November 1, 2017

GZA File No: 01.00171521.15

Re: Release Abatement Measure Plan Modification No. 3  
Construction-Related Remediation Activities  
(Former) Everett Staging Yard  
1 Horizon Way  
Everett, Massachusetts  
Release Tracking Number (RTN) 3-13341

PROJ MGR: DEL	DESIGNED BY: MMS	CHECKED BY: LF	FIGURE 2A
DATE: SEPT 27, 2017	DRAWN BY: JJZ	SCALE: AS SHOWN	
	PROJECT NO. 01.0171521.52	REVISION NO.

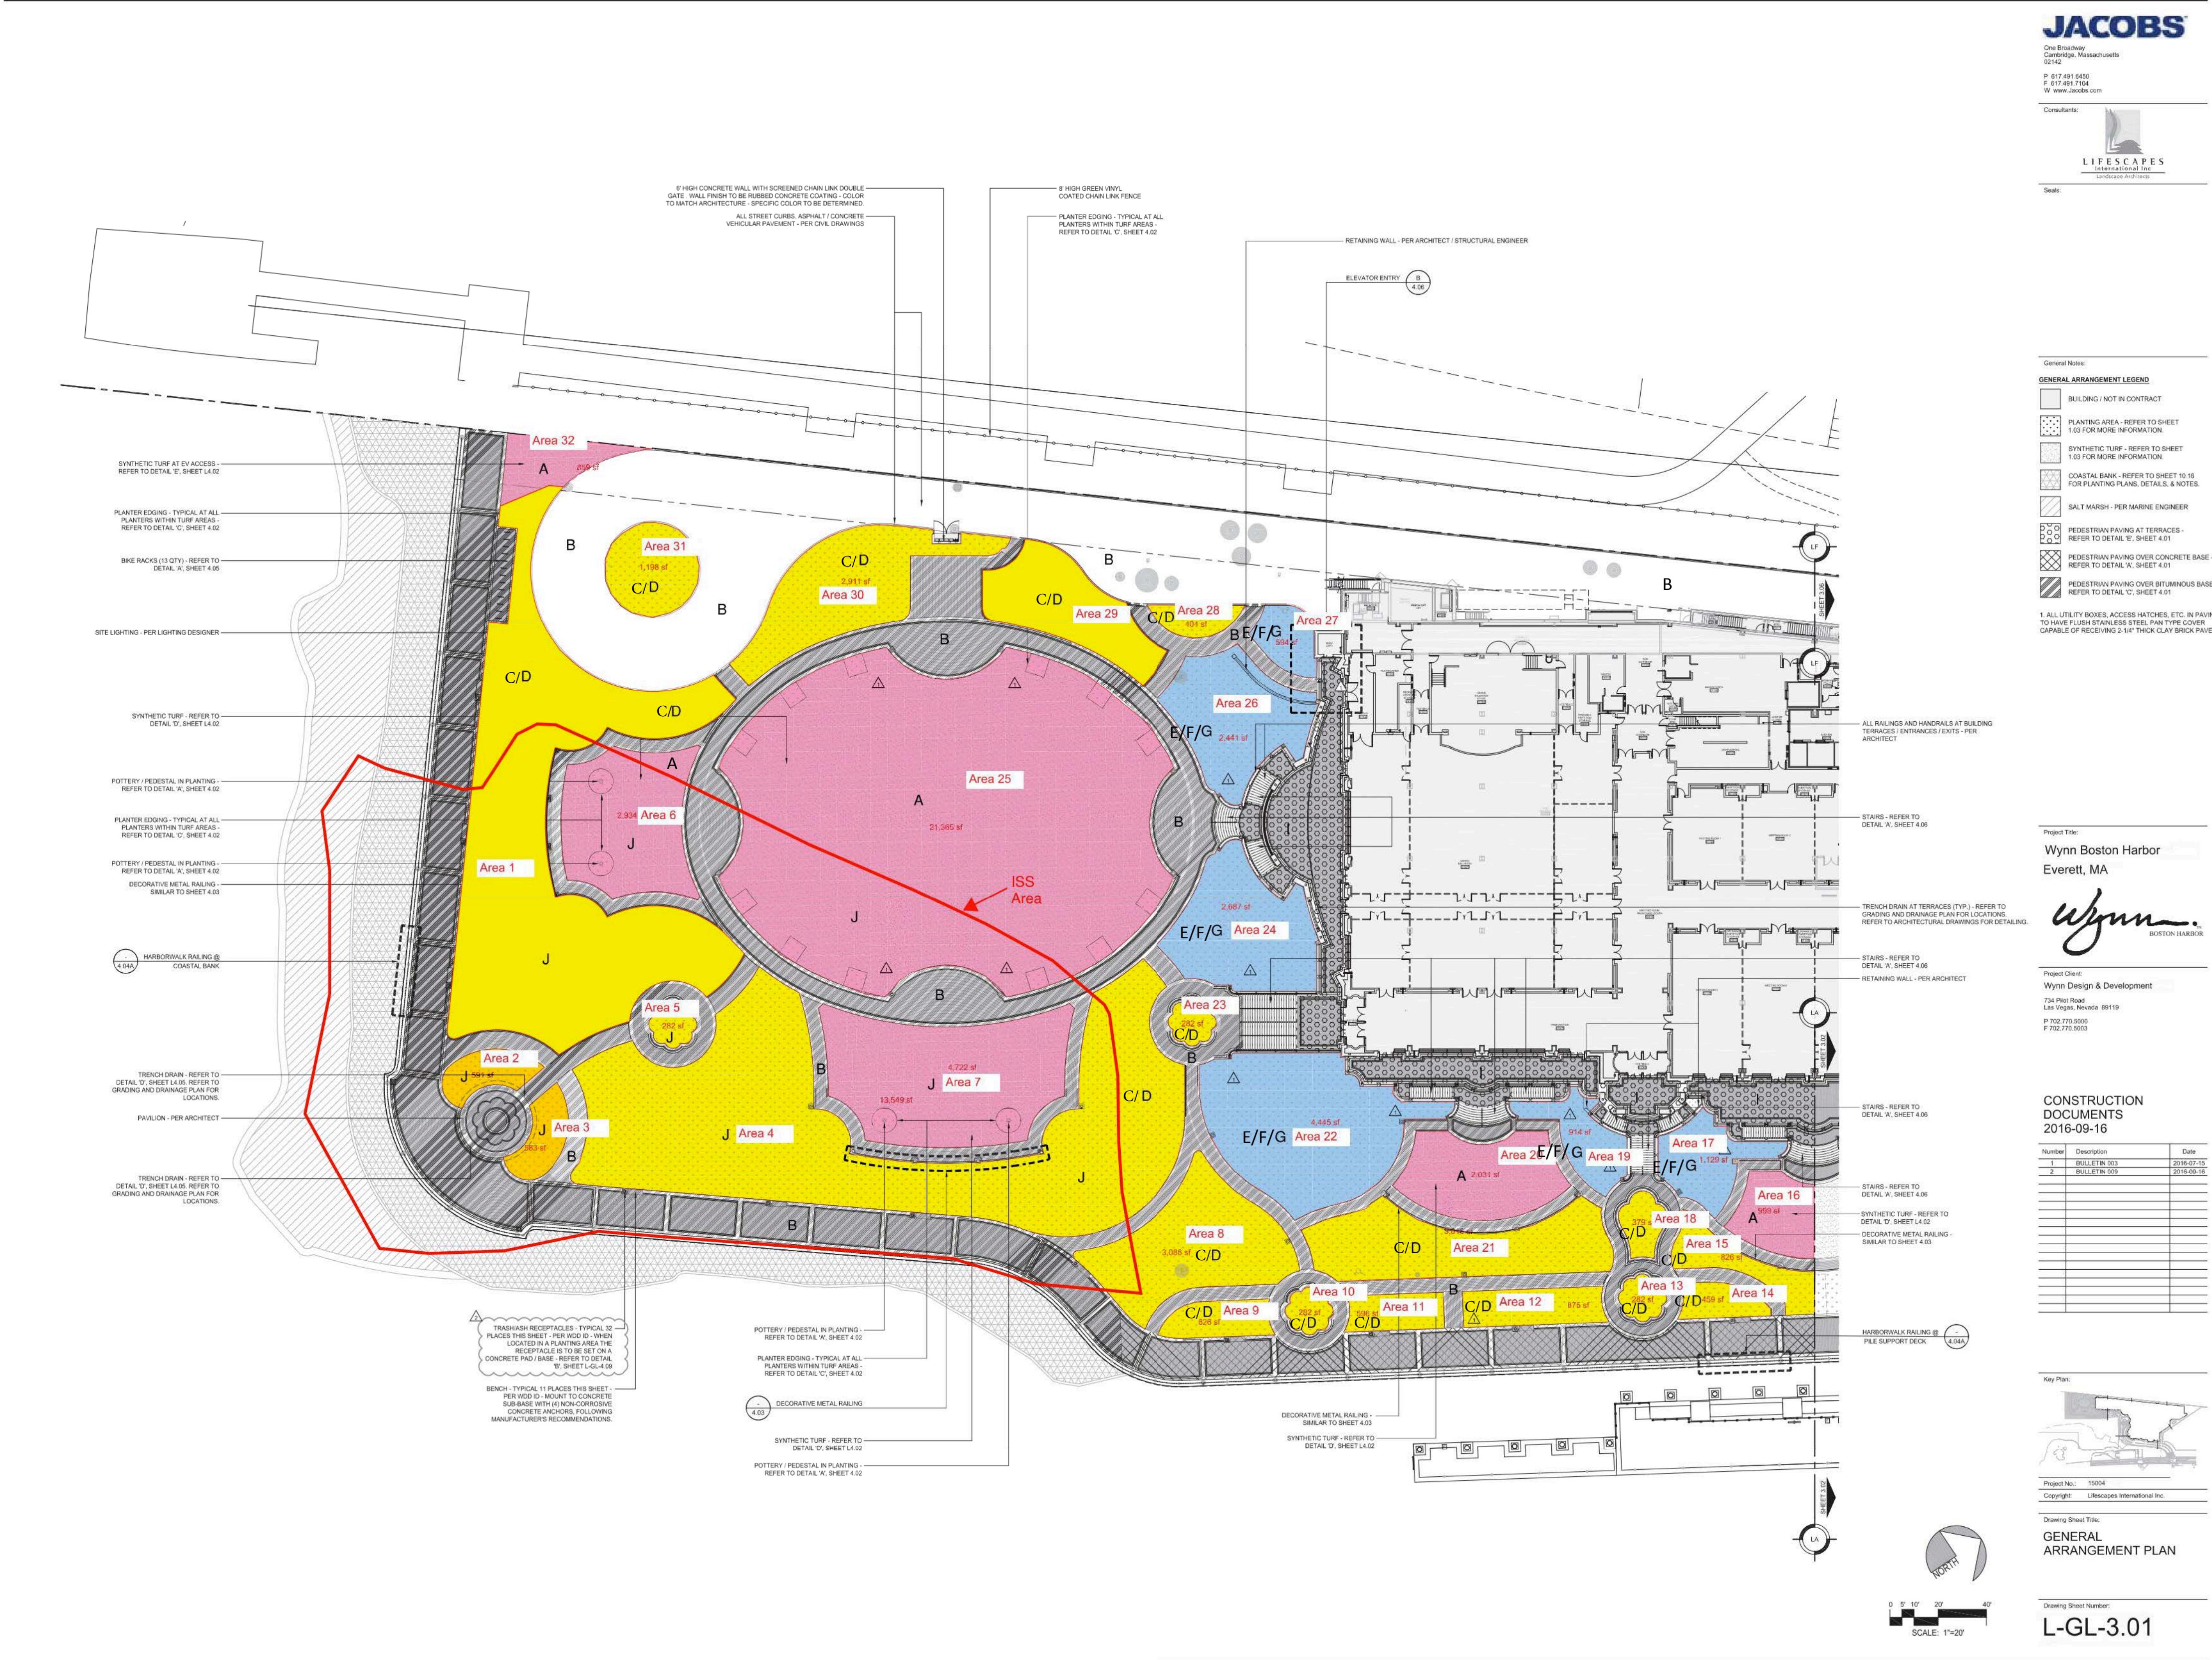
Please refer to the attached **Figures 2A** through **2F** for the locations where the cross-sections described on **Figure 3** will be implemented. Applicable sections on **Figure 3** are referenced by letter designation on **Figures 2A through 2F**. Please refer to **Appendix C** for manufacturer information and lab testing data on the above-described marker layer and shovel-resistant materials.
